Re: Initial Submission Review – Harvest Crossing PA 5, 6, & 7 – Master Plan Amendment, Site Plan, & Plat
Application Number: **DA-1786-03**
Case Numbers: **2005-7007-03, 2022-4017-00, 2022-3049-00**

Initial Submission Review

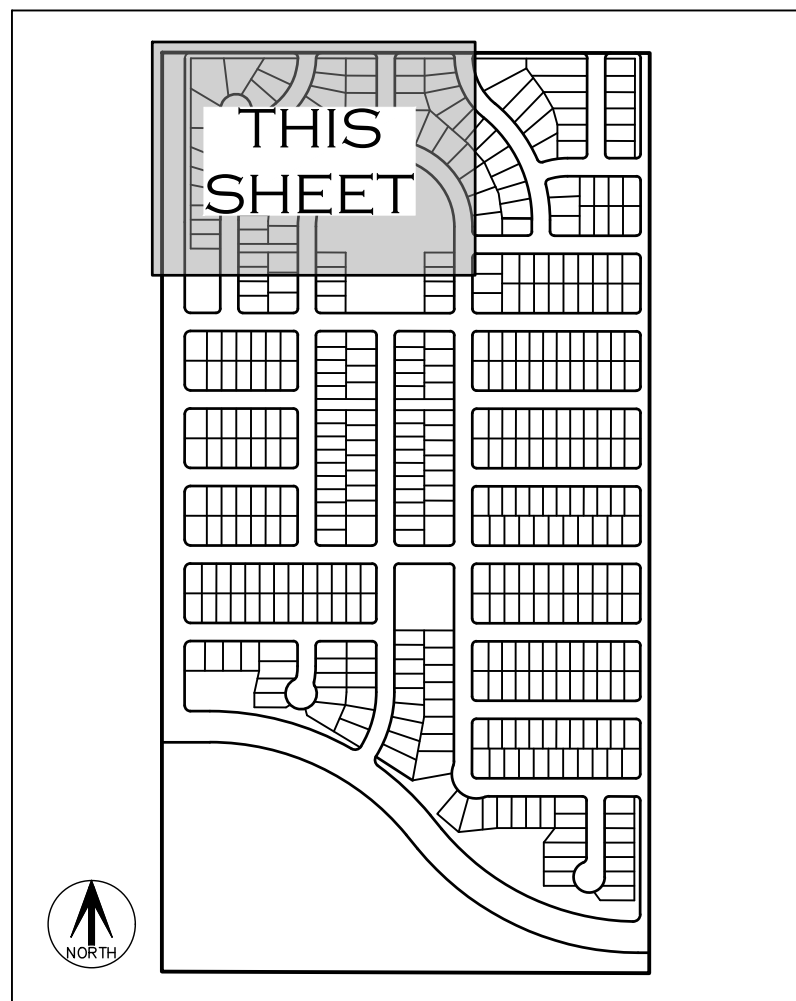
Include the 5.5' sidewalk easement as shown on the site plan.

DEVELOPER		DATE OF PREPARATION:	03-17-2022
RICHMOND AMERICAN HOMES OF COLORADO, INC.		SCALE:	1" = 40'
4350 S. MONACO STREET #500 DENVER, COLORADO (720) 977-3841		SHEET 7 OF 11

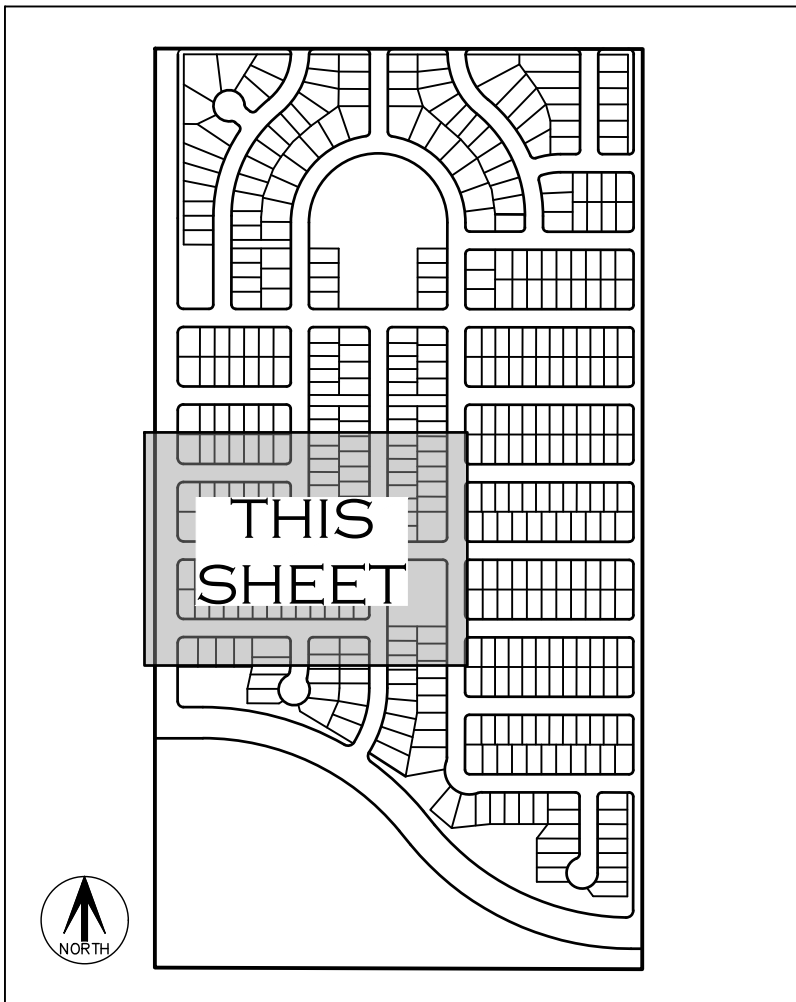
Change the 10' U.E. covering the 6' G.E. - since the Gas easement is exclusive, the 10' U.E. will need to be revised to a 4' U.E. adjacent to the 6' G.E. Thus creating a 10' area for these easements (apply to all situations hereon) (Typ.)

DATE OF PREPARATION:	03-17-2022
SCALE:	1" = 40'
S H E E T 10 O F 11

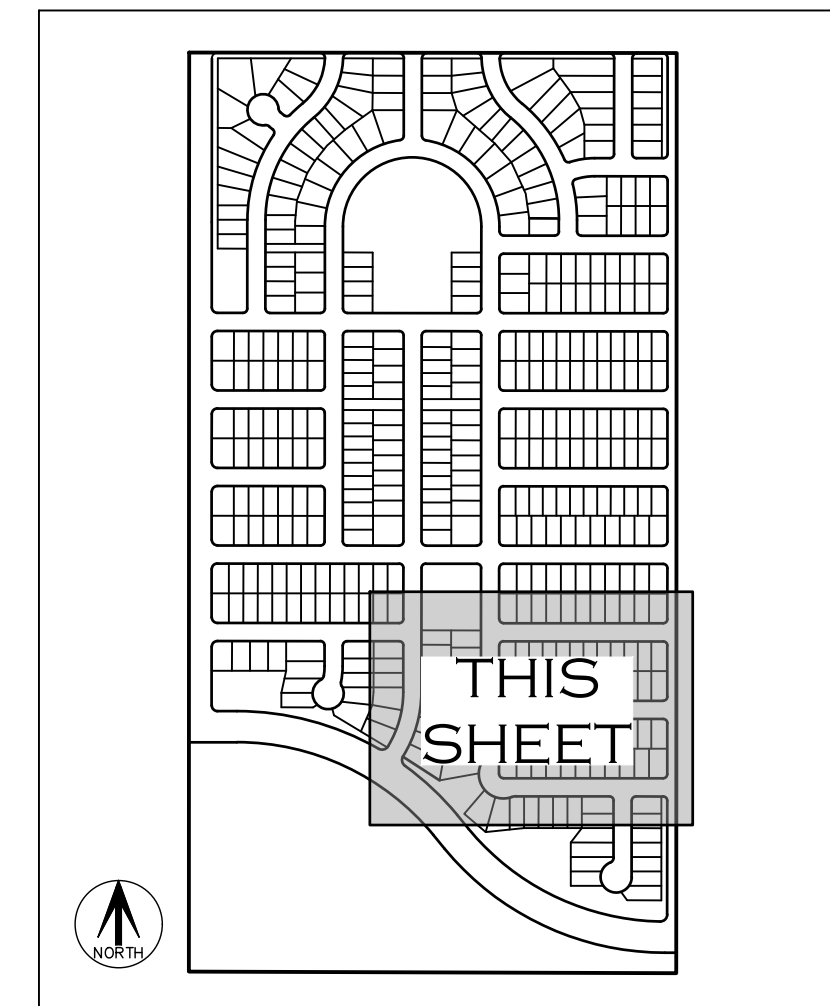
Change the 10' U.E. covering the 6' G.E. - since the Gas easement is exclusive, the 10' U.E. will need to be revised to a 4' U.E. adjacent to the 6' G.E. Thus creating a 10' area for these easements (apply to all situations hereon) (Typ.)
